ANN ARBOR DESIGN REVIEW BOARD

Staff Report

PROJECT: 545 South Main Street
Project No. DR19-002

Figure 4 - Floodplain

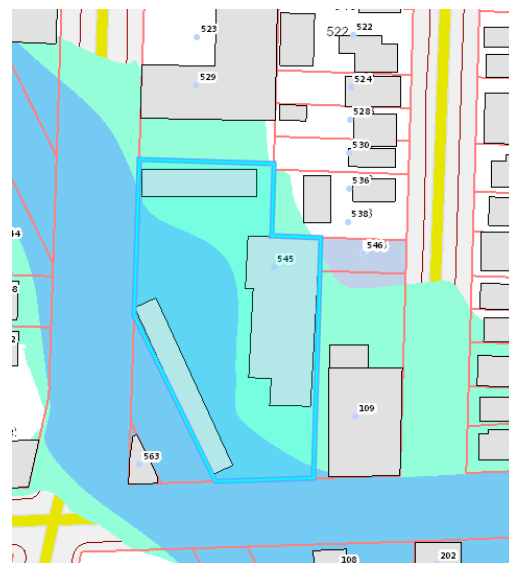
d. **Floodplain** – The 100-year, or 1% Chance, Floodplain of Allen Creek covers the entire site. The main building and north shed are in the flood fringe (shown in green on Figure 4) and the west shed is in the floodway (shown in blue in Figure 4). City policy encourages all buildings in the floodway to be removed. No new barriers such as fencing or walls are permitted in the floodway. Buildings in the flood fringe must be flood-proofed when construction costs exceed 50% of the market value of that particular building. It appears the improvements to renovate the main building into a restaurant and brewery

must include flood proofing. Also, it appears bathrooms are proposed in the west shed. Any plumbing fixture connected to the sanitary sewer system must be elevated above the base flood elevation.
